**SITE PLAN REVIEW TECHNICAL ADVISORY COMMITTEE
PORTSMOUTH, NEW HAMPSHIRE**

APRIL 7, 2020

AGENDA

- A. The application of the **Maud Hett Revocable Trust, Owner**, for property located on **Banfield Road** requesting Conditional Use Permit approval for an Open Space Planned Unit Development according to the requirements of Section 10.725 of the Zoning Ordinance and Site Plan Review approval for the construction of 22 single-family homes and a new road with related parking, utilities, landscaping, drainage and associated site improvements. Said property is shown on Assessor Map 256 Lot 02 and lies within the Single Residence A (SRA) District.

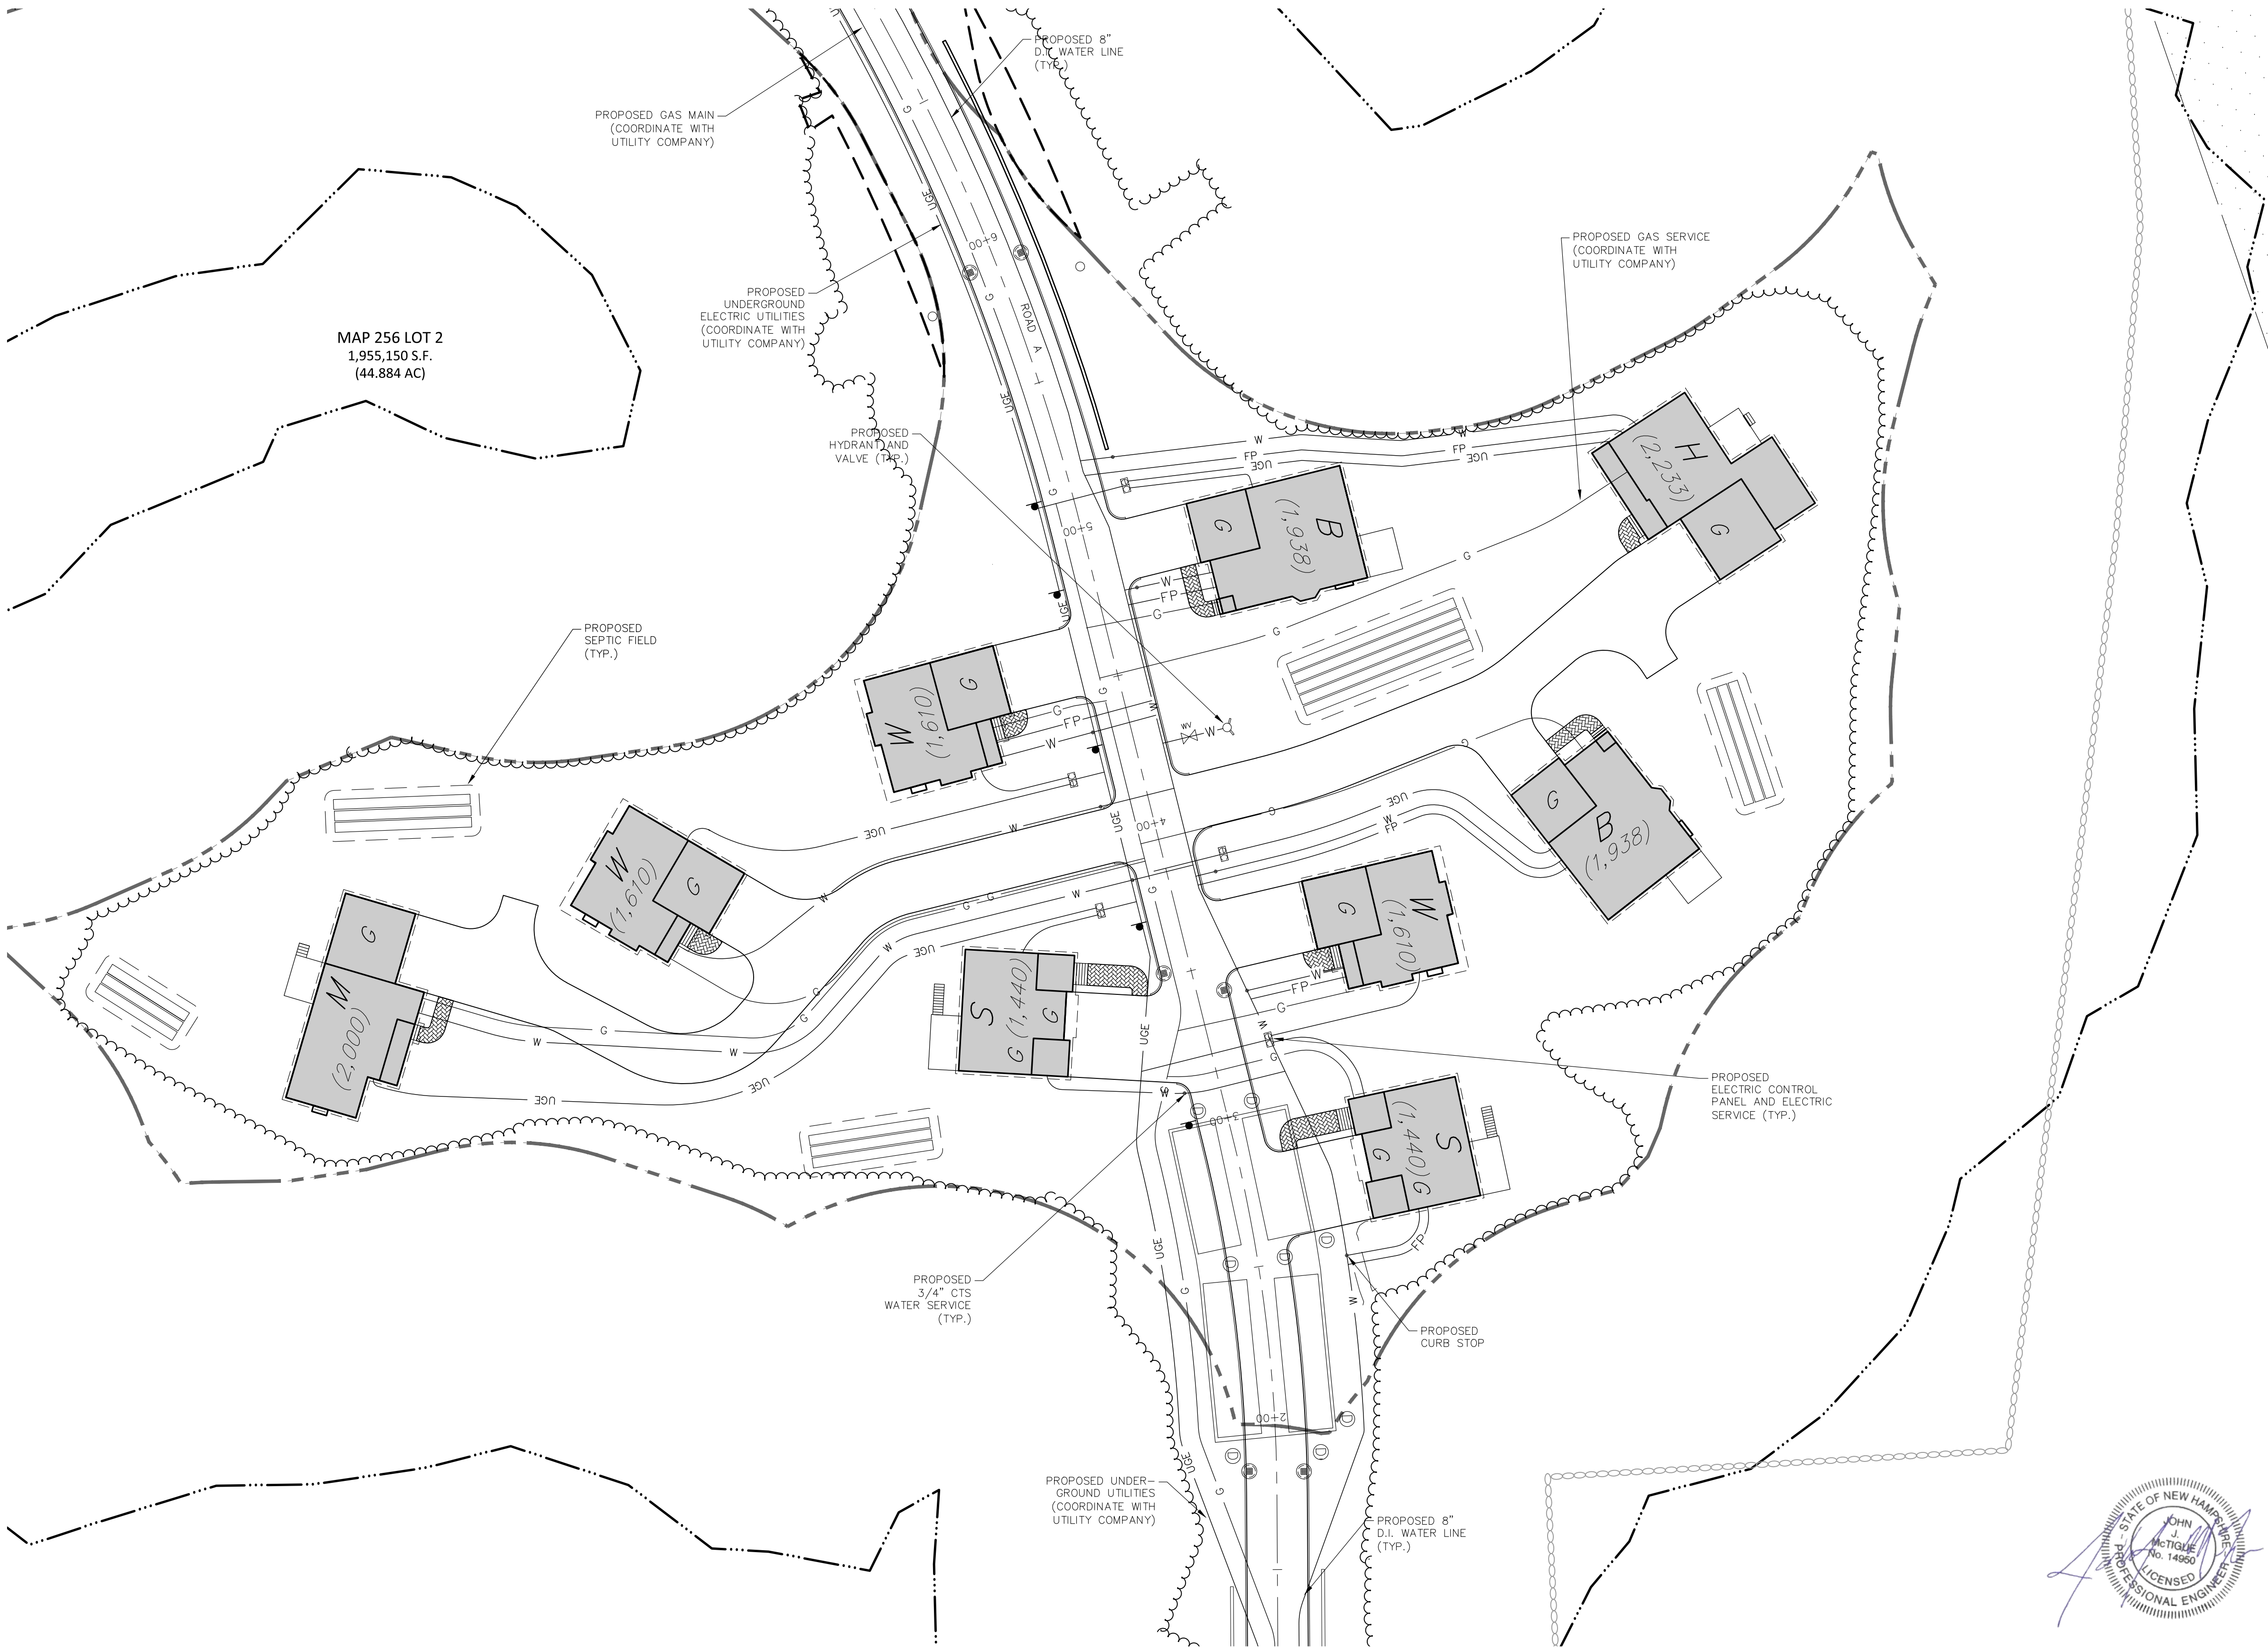
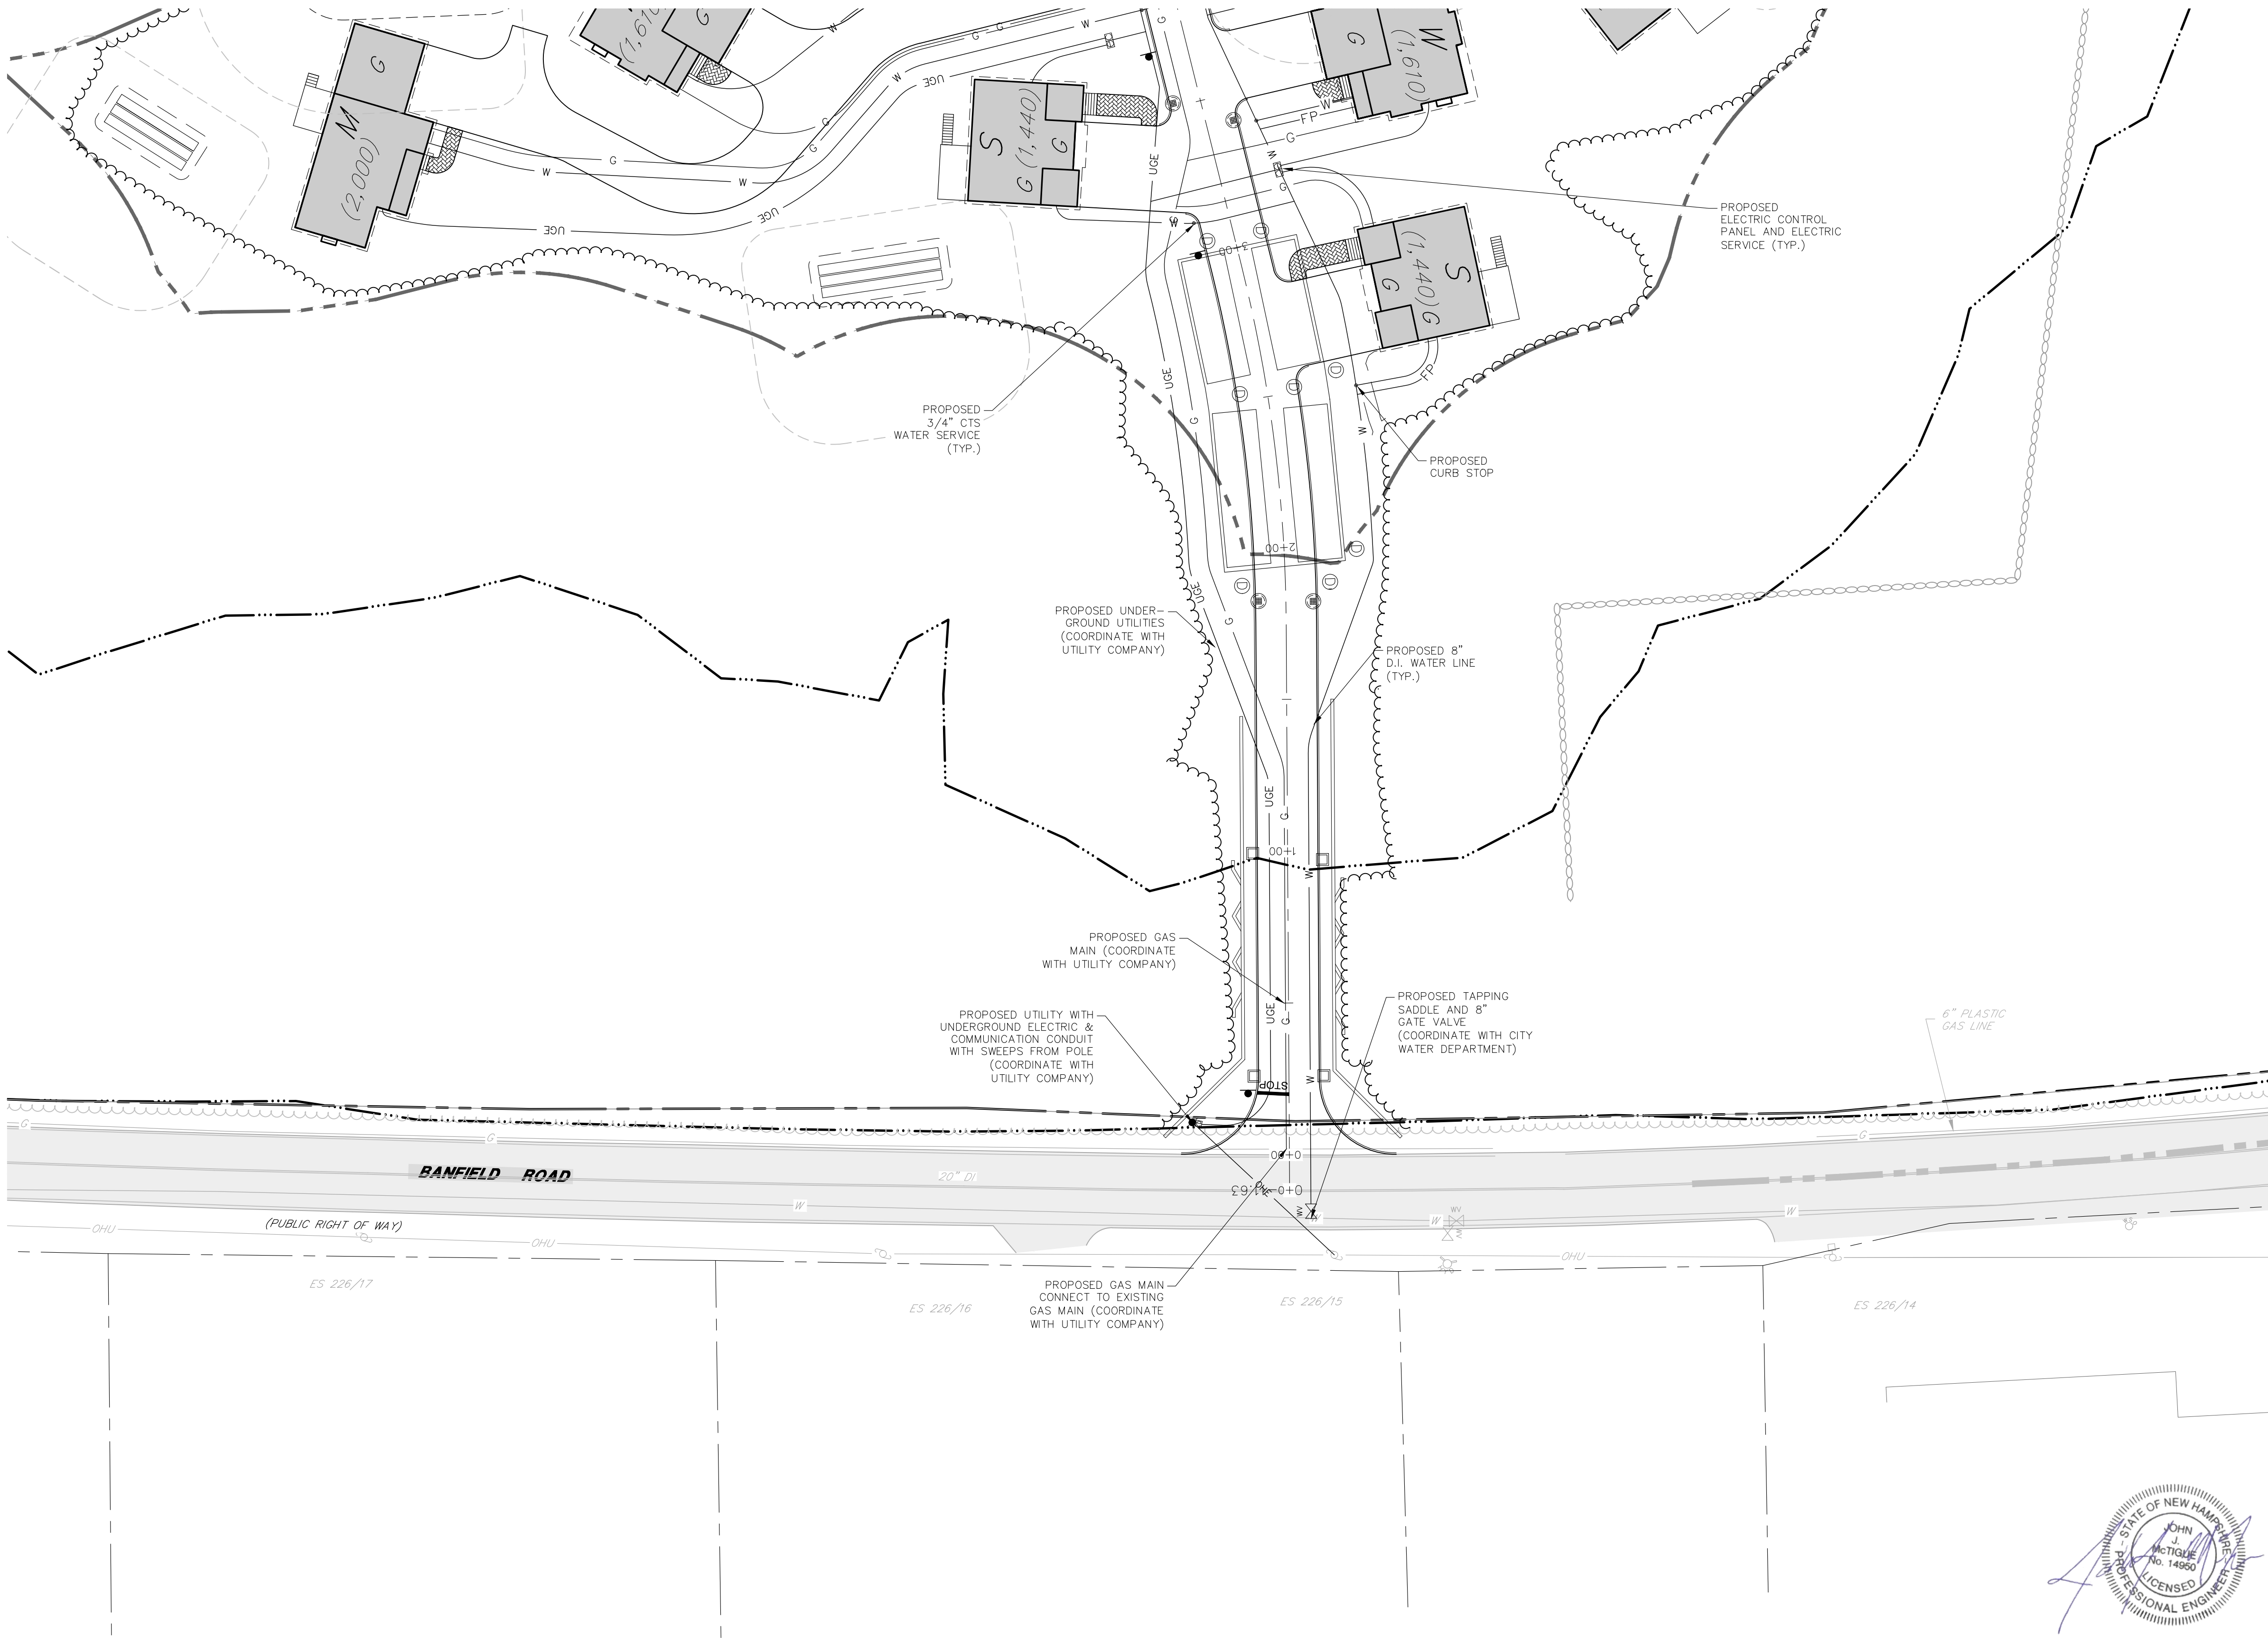
2. The utility plans are not showing water lines for fire suppression.
Response: Additional water services are shown for fire suppression. (See Sheets C-12 through C-15.)

Response: An 8" water main has been provided on the plans. (See Sheets C-12 through C-15.)
